**Carrier/Carlyle  
05G Compressors  
Sump - Oil Sight Glass Change**

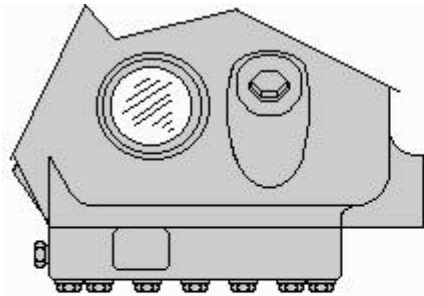
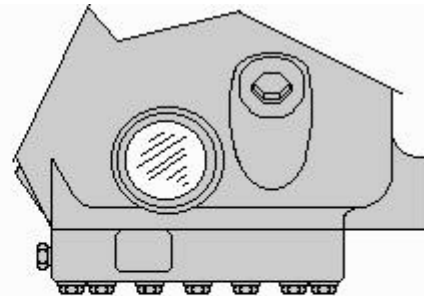
Original sight glass location and proper oil level.

Current sight glass location and proper oil level.

1/4  
Sight  
Glass

— Maximum  
— Minimum

Proper oil charge is 6 1/2 pints.
